Japanese position to the proposals from TU-G and TU Wien

9th HDH Informal meeting, 21-23 March, 2012

Japanese position to the proposals by TU Wien and TU Graz

Japan HILS (vehicle based approach)

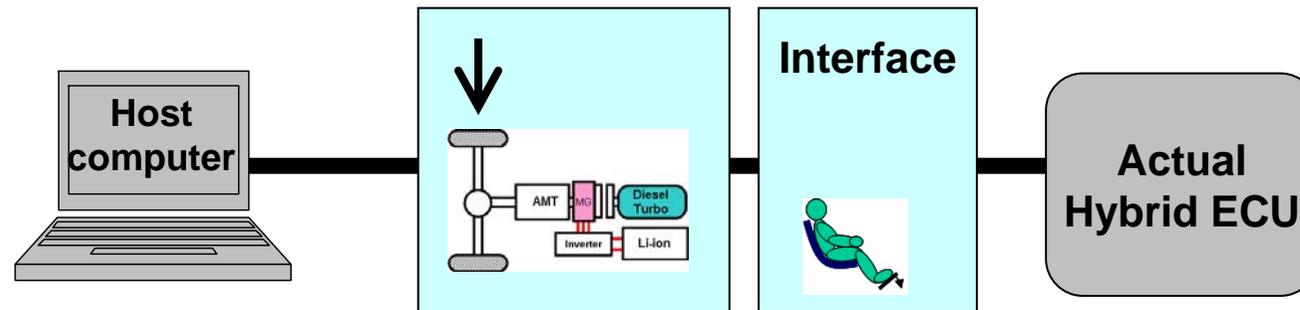
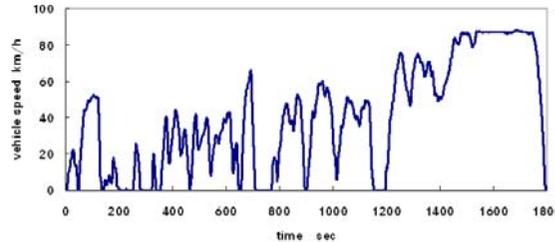
It is possible to reflect WHVC speed/power profile(as gradient) for each harmonized vehicle.

However it is independent of WHTC.

Japan understanding of WHDHC

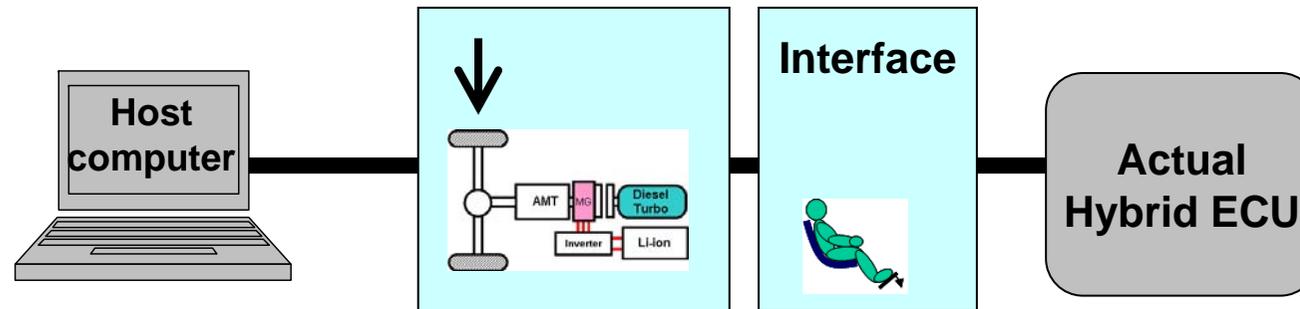
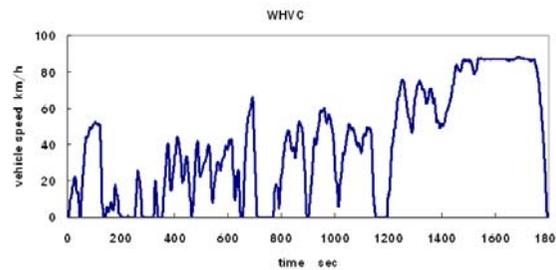
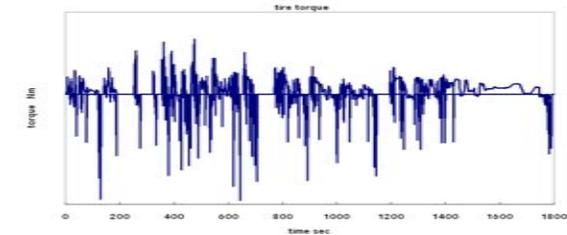
It is possible to reflect WHTC power profile.
However it is independent of WHTC speed/torque.
